**HISTORIC DISTRICT  
REVIEW COMMISSION**

**HISTORIC DISTRICT REVIEW COMMISSION  
REVISED Regular Meeting Agenda**

**HDRC Case No. 19-001D**

**HDRC Case No. 19-001PH**

**PREVIOUS CASES / ADDITIONAL INFORMATION**

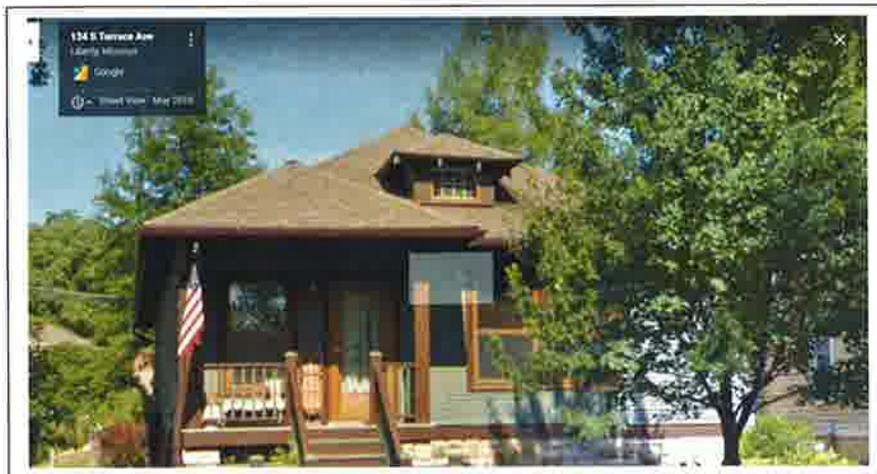
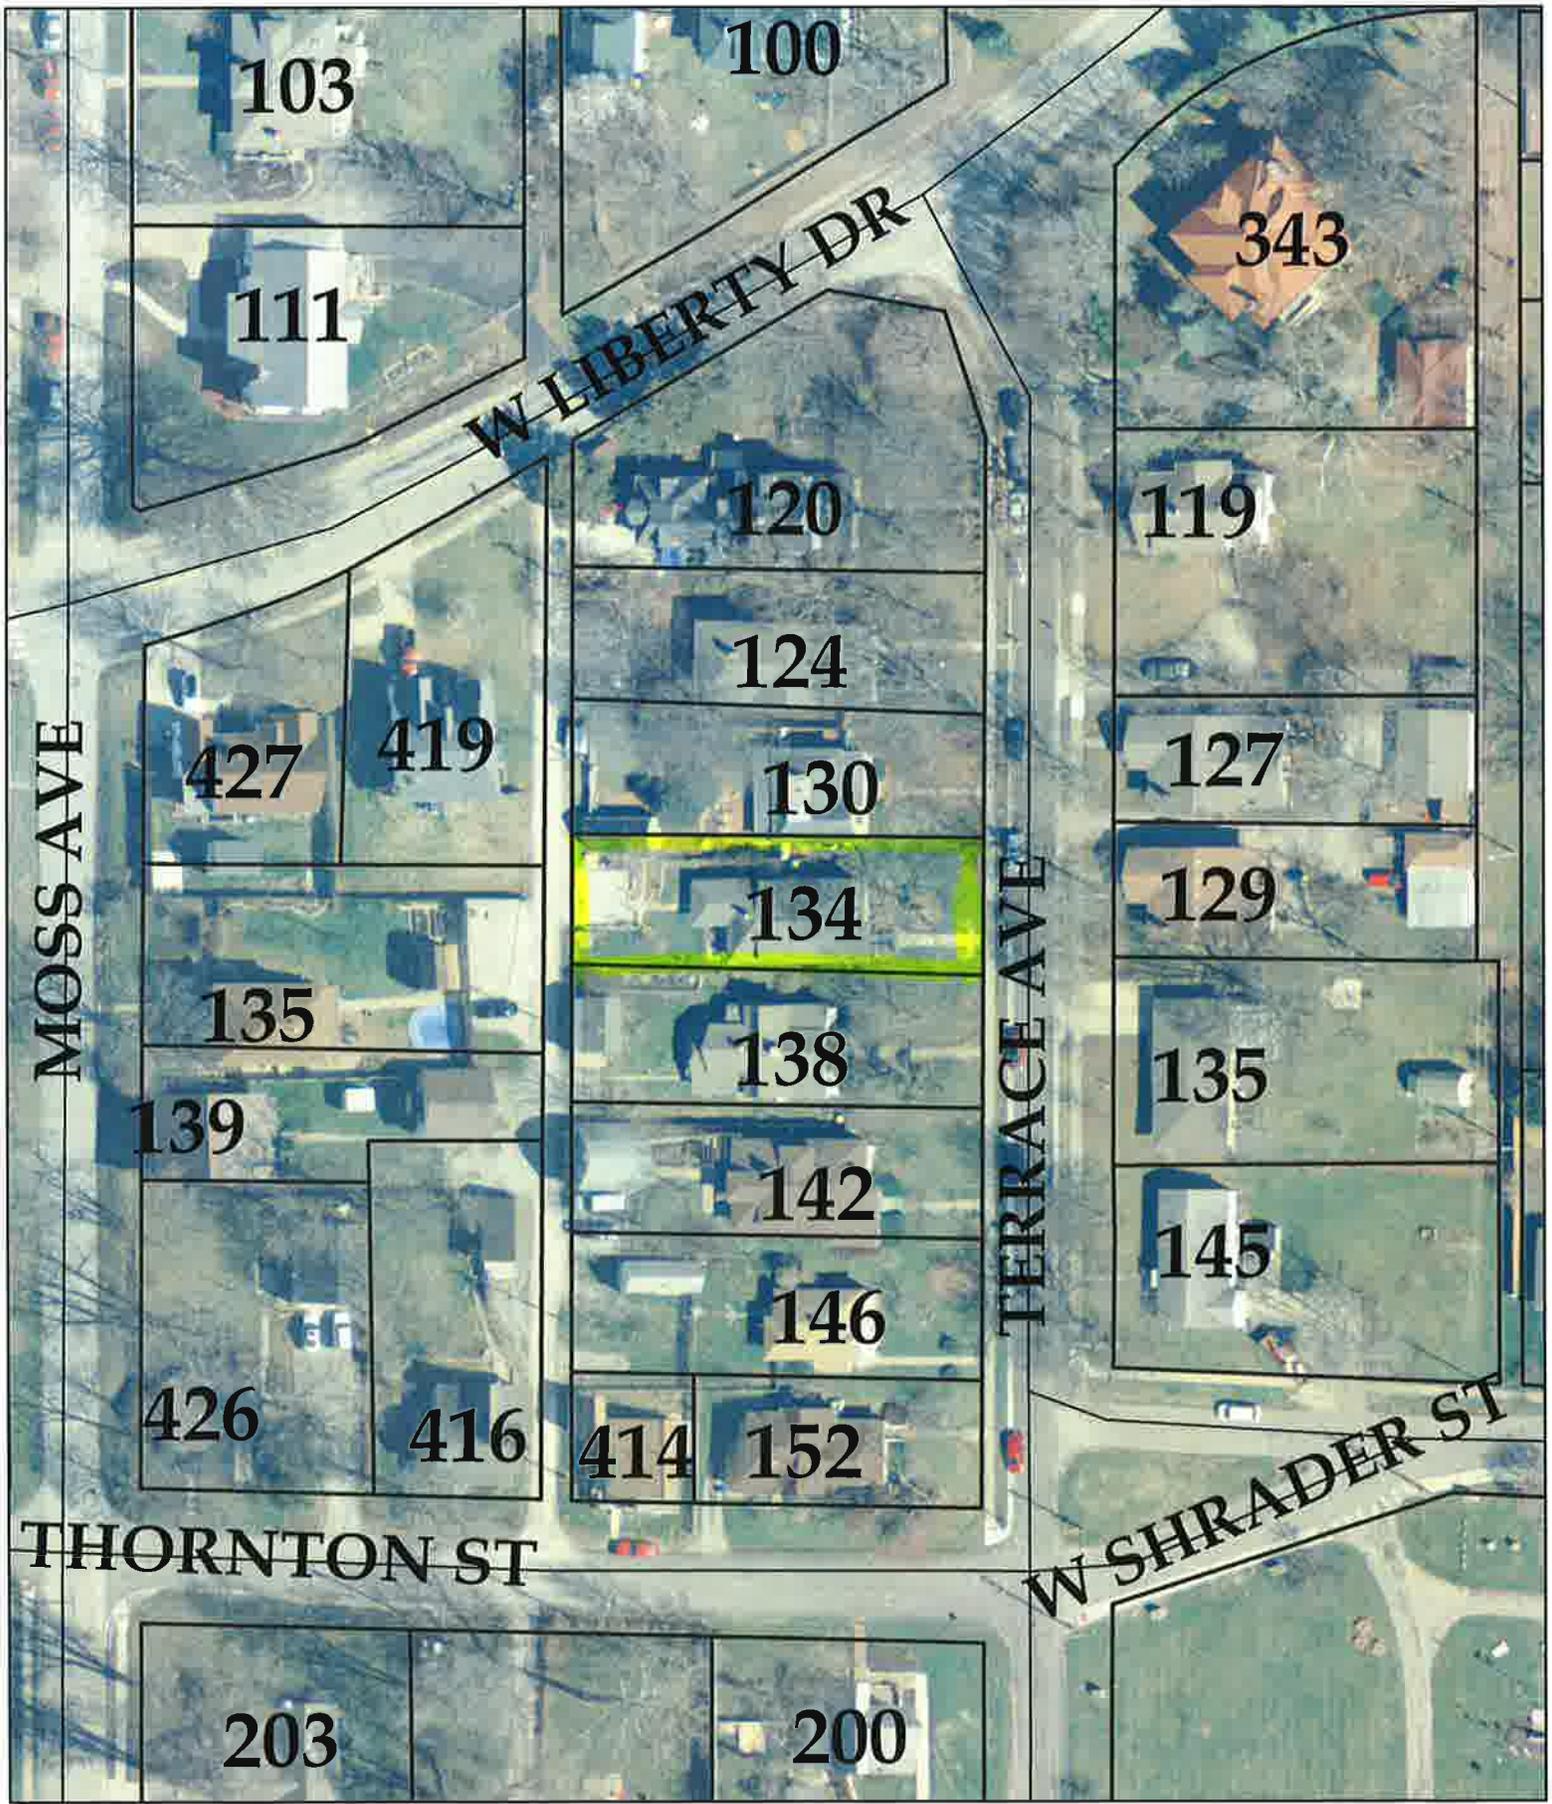
The temporary walkway will be constructed of compatible and complimentary materials and is appropriate.

The proposed temporary walkway will be installed over the existing stone walkway in order to allow for use of a walker, allowing for access to the back of the home.

The application meets the standards for review and guidelines; therefore staff recommends approval of HDRC case #19-001PH.
